SUBJECT: REQUEST FOR ADDITIONAL INFORMATION REGARDING TRIENNIAL UPDATE  
TO DECOMMISSIONING FUNDING PLAN (ENTERPRISE PROJECT IDENTIFIER  
L-2018-DFA-0001)

Attachment  
DFP RAI Responses

EHS&L Document  
Decommissioning Funding Plan

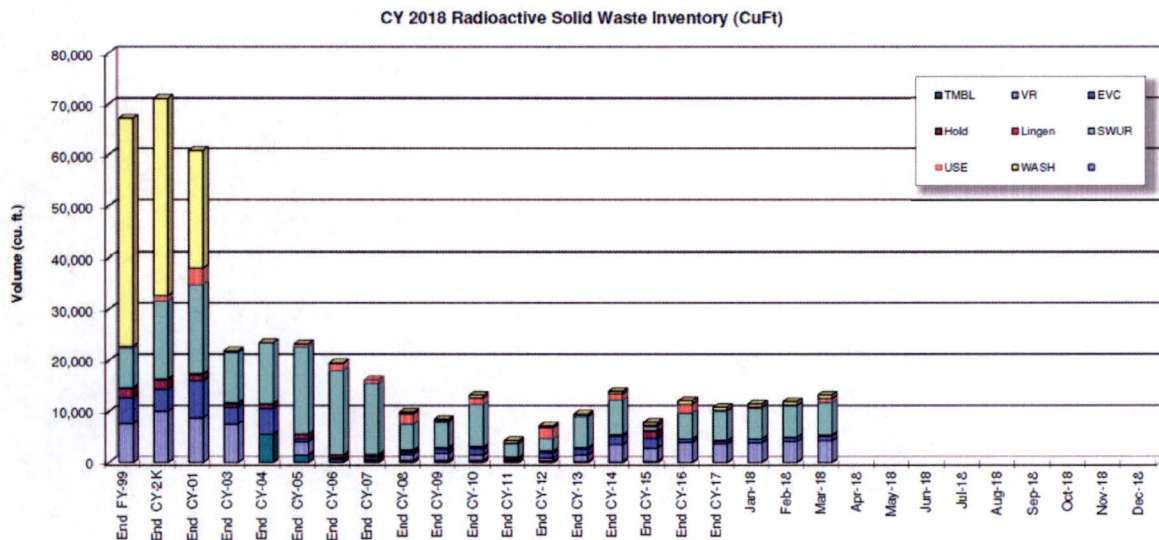
- b. Waste inventory increases- the e-mail does not address this factor. A statement is needed regarding changes in the waste inventory since the last update and the reason for the changes (if any).

**Response:** The waste volume on is shown on the following graph. The current waste inventory as of March 31 is 13,225 ft<sup>3</sup>
